ATR on Quality Control Check Report. (Apartments)

Quality Control Check Report. Stage: After Finishing Stage III (Apartments)

MAYFLOWER PLATINUM

Details of Additions & Alterations

WORKING DRAWING OF FLAT NO. A-1

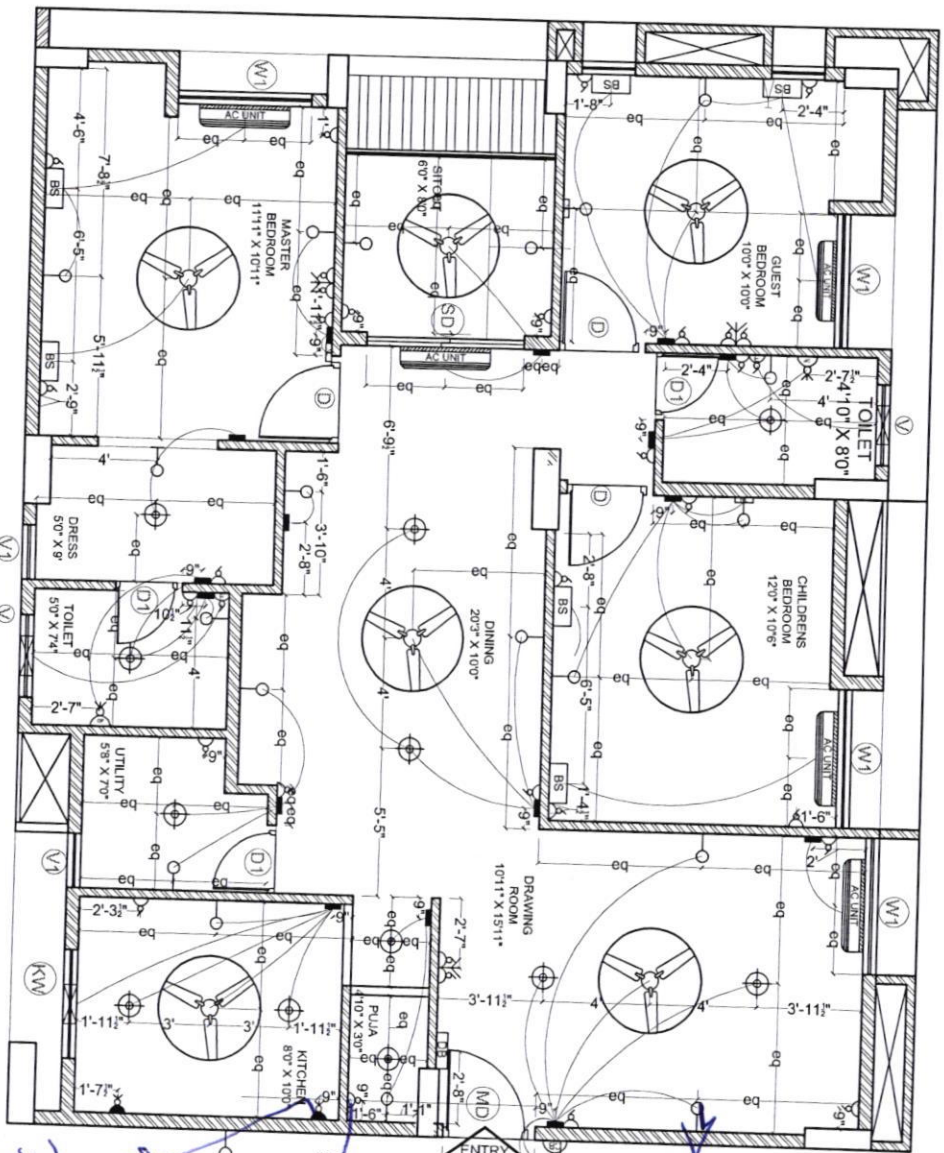
Through column same
 Staff room
 required
 02/10/19
 Jyoti

ELECTRICAL PLAN OF FLAT-A1

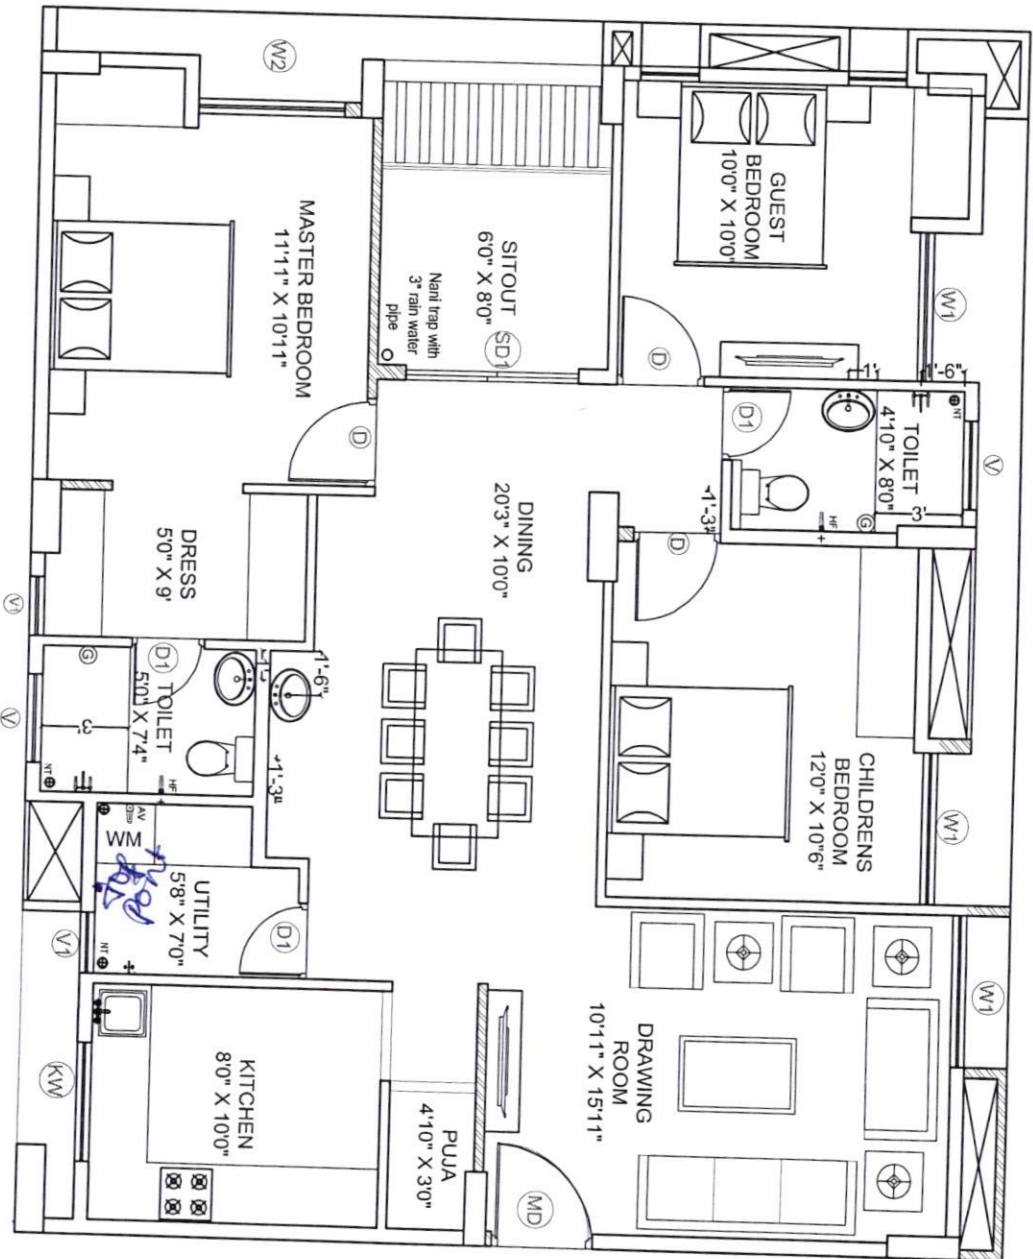
3 Bedroom 2 way switches & wiring
TV Point change to doorwall (marked on plan)

Handwritten notes on the plan: 'TV point', 'switch point', 'AC unit', '1' floor', '1' floor', '1' floor'.
